EWEA and EPIA main concerns and proposals for solutions

ENTSO-E Network Code for Requirements for Grid Connection applicable to all Generators

January 2013

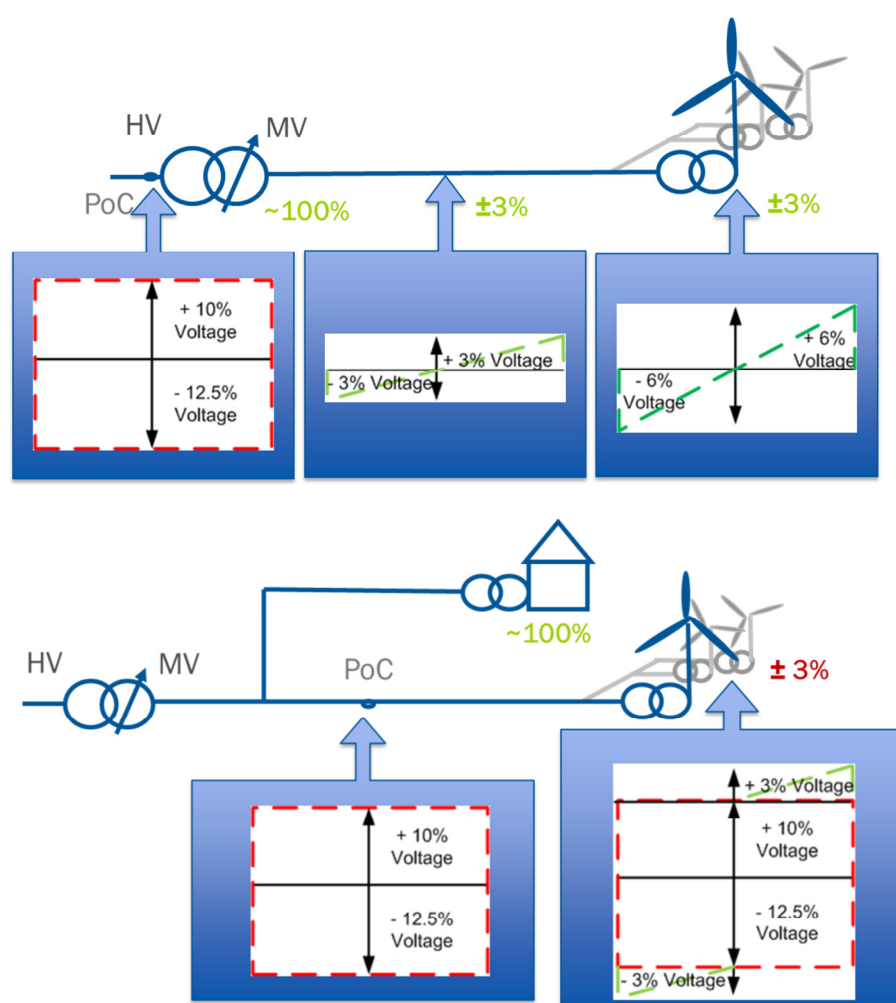
Figure 8 of Article 16 specifies that reactive capability shall be present over a voltage range from +10 to -12.5%. In high voltage grids, a tap changer reduces the large voltage fluctuations. However, for medium voltage connected plant there is no such voltage range reduction. As a consequence, requiring the same voltage operating range for reactive power capability for PPM in medium voltage networks will result in effectively wider voltage ranges than the equipment would be designed for, and thus will lead to increased investment costs for the PPM. Because there is no technical necessity for such a requirement, there will be hardly any use for this extended capability. If this NC requirement is universally applied in Europe, a large amount of investment in reactive capability will become stranded.

In this context, one should bear in mind the wording from the ACER framework guideline: “The minimum standards and requirements shall be defined for each type of significant grid user and shall take into account the voltage level at the grid user’s connection point.” The requirements in Article 16 in the NC RfG do not fully take into account the possible situations with respect to voltage level of the grid users, and thus do not respect the FGL. The requirements will in many cases negatively affect the business case of Type C and D wind plants connected at MV level.

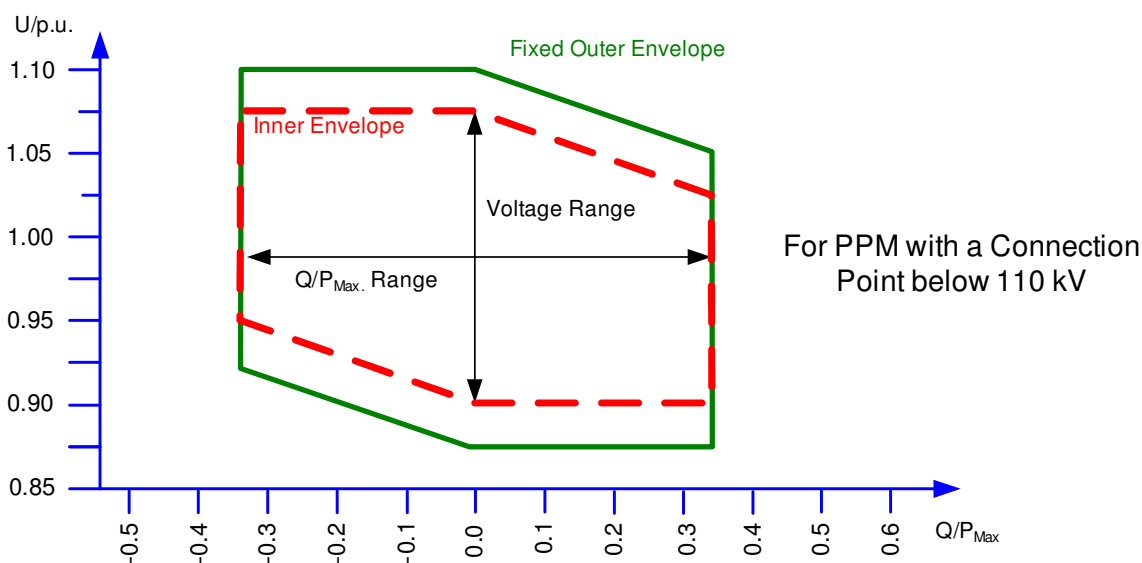
During the public consultation of the draft NC in March 2012, EWEA has proposed to ENTSO-E an amendment of the NC to take the above considerations into account. The proposal was not accepted, and no sufficient justification has been provided by ENTSO-E for its rejection. The proposal of March 2012 is therefore re-introduced here.

- Reactive power capability at maximum capacity: paragraph Article 16.3 b)2), to add the graph Figure 8bis and table 9bis, and to modify the text of the paragraph to include proper references to this figure and table.
- Reactive power capability below maximum capacity: paragraph Article 16.3 c)2), to add Figure 9bis, and to modify the text of the paragraph to include proper reference to the figure.

Synchronous Area	Maximum range of Q/P _{max}	Maximum range of steady state voltage level in PU
Continental Europe	0.66	0.175
Nordic	0.66	0.150
Great Britain	0.66	0.100
Ireland	0.66	0.175
Baltic States	0.66	0.175
